ADA Curb Ramp New Construction Inspection Form (Combination)

NW 307th

23885.56

NW Kaybern

COMBINATION RAMP (C)

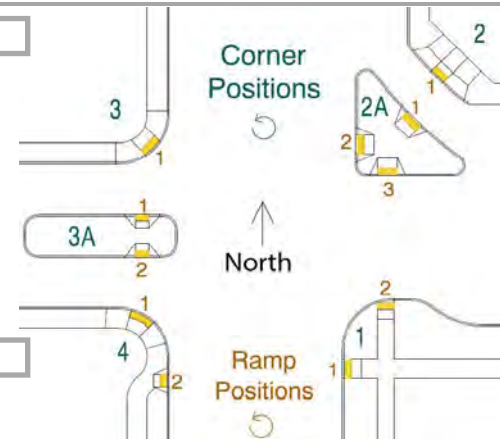
DWS IITD, TS Large Crack, Puddle in gutter at Ramp
